Derrick Law (Export Sales) Limited	
Title: MKT02049 GPS USB Communicator	
Size B	Rev 1.4 (PCB 286R3)
Date: DEC 30, 2004	Sheet 1 of 1

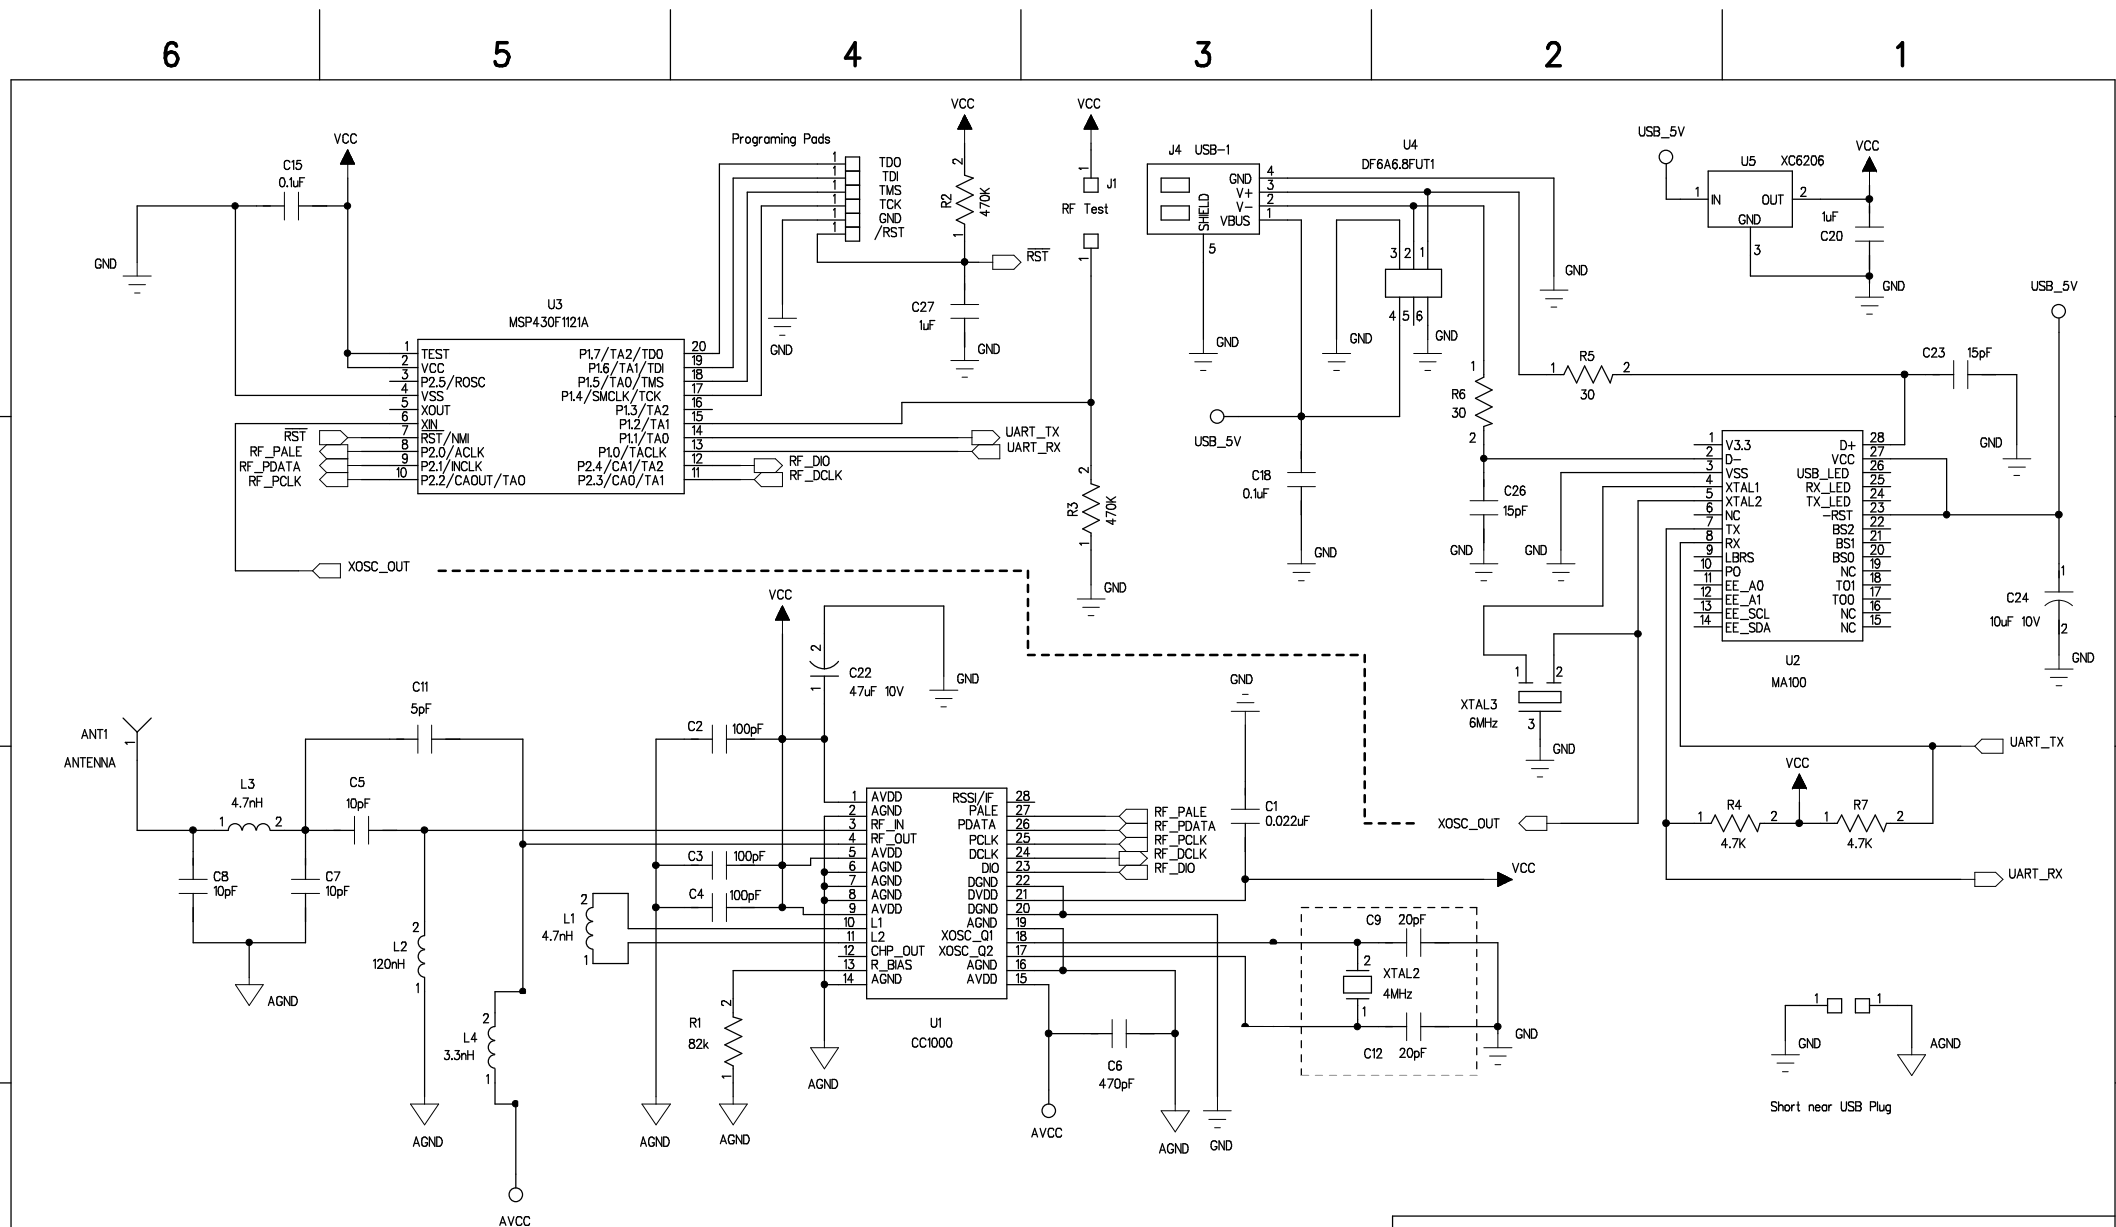
Date	Revision	By	Modifications
2004-04-24	R1.1 (286R1)	Danny	C13 & C14 changed to 15pF, C22 increased to 47uF, C27 added
2004-04-24	R1.2 (286R2)	Danny	antenna length modified, shielding pads added
2004-10-28	R1.3	Danny	32K crystal, C13, C14 removed
2004-12-29	R1.4 (286R3)	Danny	XC6206 added, shielding pads modified
